# Access Compliance Report

## Public Rights-of-Way

### (Curb Ramps)

Intersection ID: 12194	Main Street: S_CEDAR_ST	Cross Street: W_HILL_ST	Location: E
ADA ID: 05EBBF5E0E83	Ramp Type: PerpDiag	Initial Pass/Fail: Fail	Overall Compliance: No
		Severity Score: 10

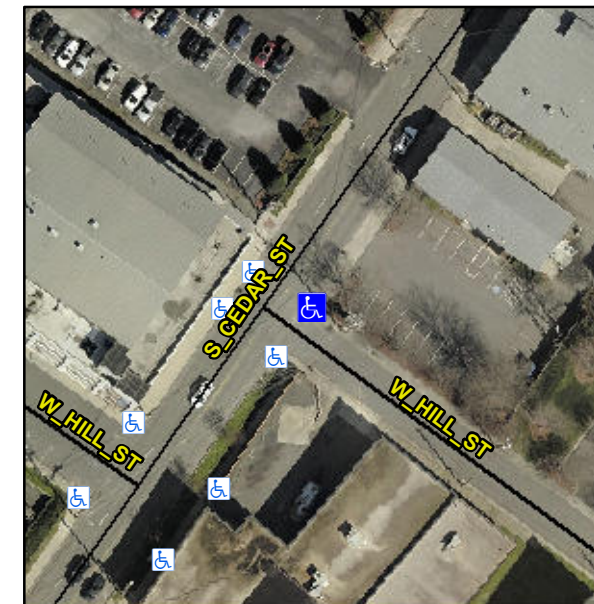
**R304.5.1, R304.5.3**

Compliance	Description	Data	Compliance	Description	Data
N/A	Ramp Length (in)	60.0	Yes	Ramp Slope (%)	6.4
No	Ramp Width (in)	36.0	No	Ramp XSlope (%)	3.6
N/A	Flare Type LT	N/A	N/A	Flare Type RT	N/A
N/A	Flare Slope LT (%)	N/A	N/A	Flare Slope RT (%)	N/A
N/A	Flare Traversable LT?	N/A	N/A	Flare Traversable RT?	N/A
N/A	Landing Length (in)	N/A	N/A	DWS Provided?	N/A
N/A	Landing Width (in)	N/A	N/A	DWS Contrast?	N/A
N/A	Landing Slope (%)	N/A	N/A	DWS Length (in)	N/A
N/A	Landing X Slope (%)	N/A	N/A	DWS Full Width?	N/A
N/A	Landing Curb? (Y/N)	N/A	N/A	DWS Offset (in)	N/A
N/A	Shared Landing?	N/A			
N/A	Gutter Ponding?	N/A	N/A	Gutter Slope (%)	N/A
N/A	Gutter Lip Ht (in)	N/A	N/A	Gutter X Slope (%)	N/A
N/A	Painted X Walk1?	No	N/A	Painted X Walk2?	No
	X Walk 1 Direction	To NW		X Walk 2 Direction	To SW
N/A	X Walk 1 Width (in)	N/A	N/A	X Walk 2 Width (in)	N/A
	X Walk 1 Slope (%)	4.2		X Walk 2 Slope (%)	3.2
	X Walk 1 X Slope (%)	1.9		X Walk 2 X Slope (%)	1.8

**Remove & Replace Curb Ramp With Two New Directional Ramps or Equivalent.**
